Meeting Agenda

Franklin Municipal Planning Commission

Thursday, February 28, 2019

C3.0

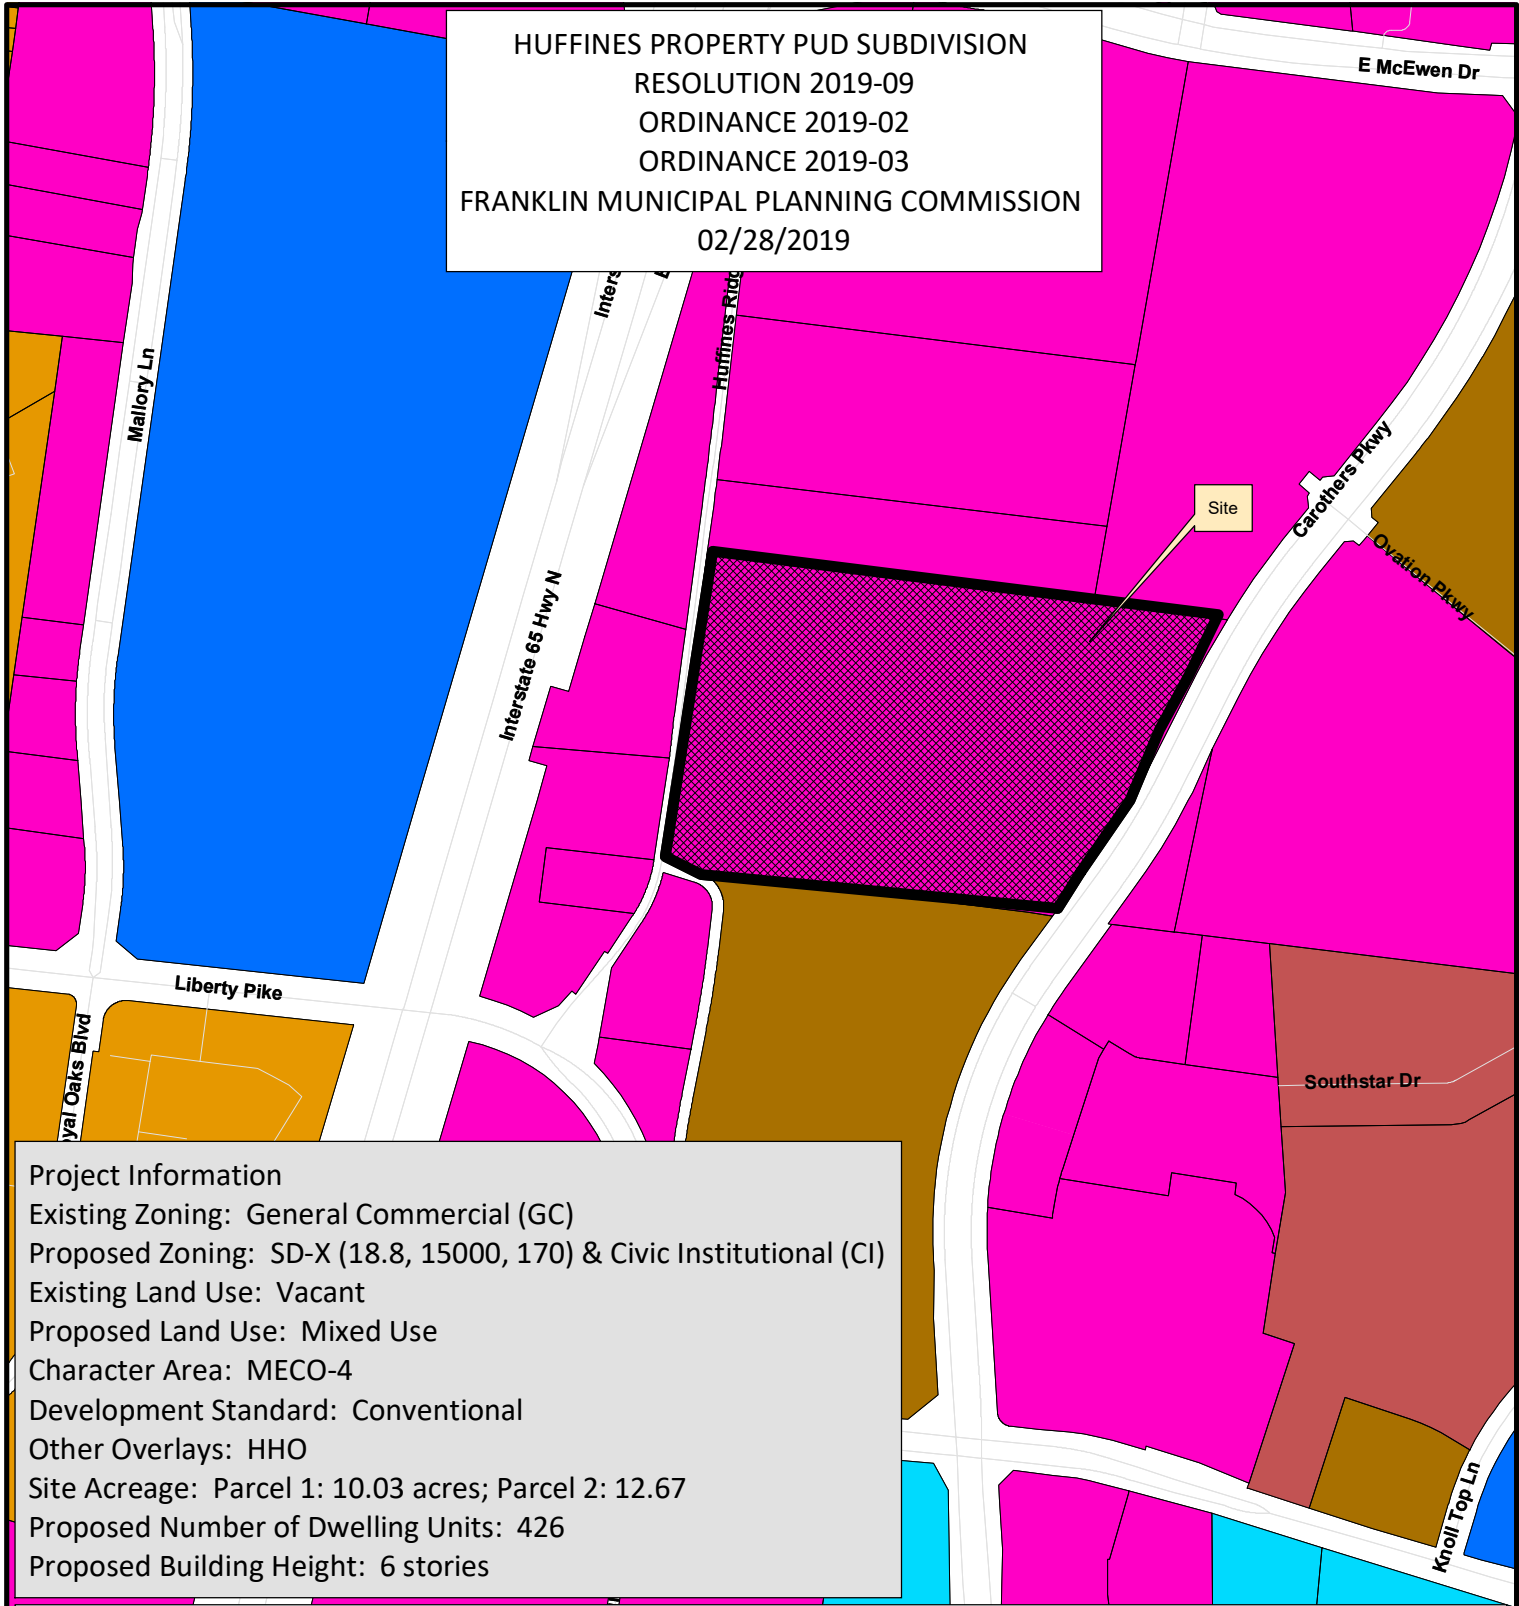
joe.marlo@franklin.tn.gov	At Site Plan, no portion of private streets or drives shall exceed 10%, including the area clouded below. (C3.1)

At Site Plan, no utilities will be permitted within pervious paver areas. (C3.1)

PARKLAND
DEDICATION
PLAN
SHEET

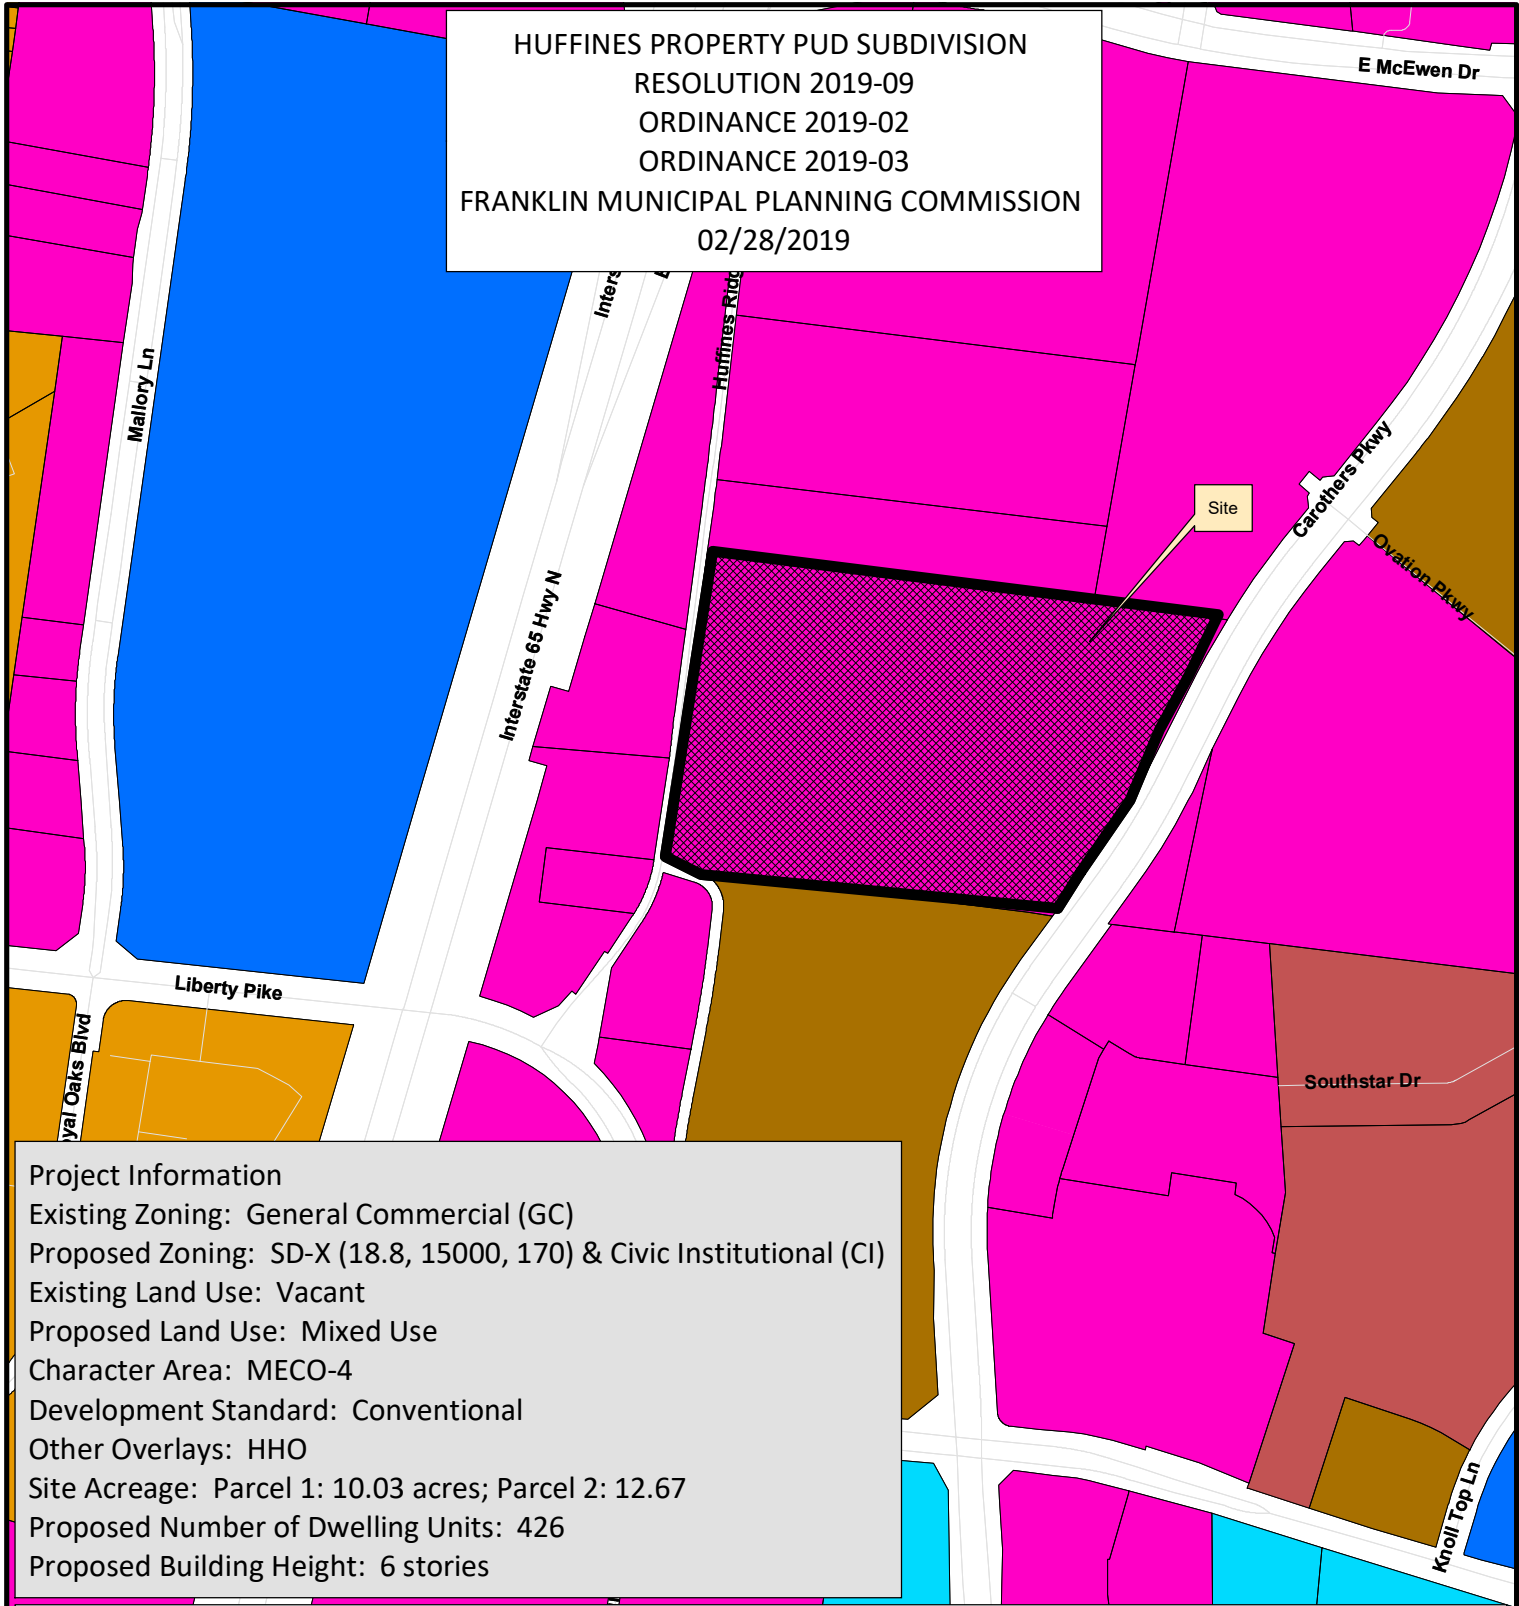
A new sheet, C2.2 Parkland Dedication Plan, has been added to the set to outline and show the proposed uses of the dedicated parkland.

The new information that is included on sheet 6, C2.2, will be updated in the Parkland Impact Fee contract and sent to the Law Dept. for approval. This can go to Planning Commission but in the event that Law has issues with the contract this could be delayed at the BOMA.

Sheet C2.3 detailing the Parkland Dedication Strategy has been added to the development plan submittal.
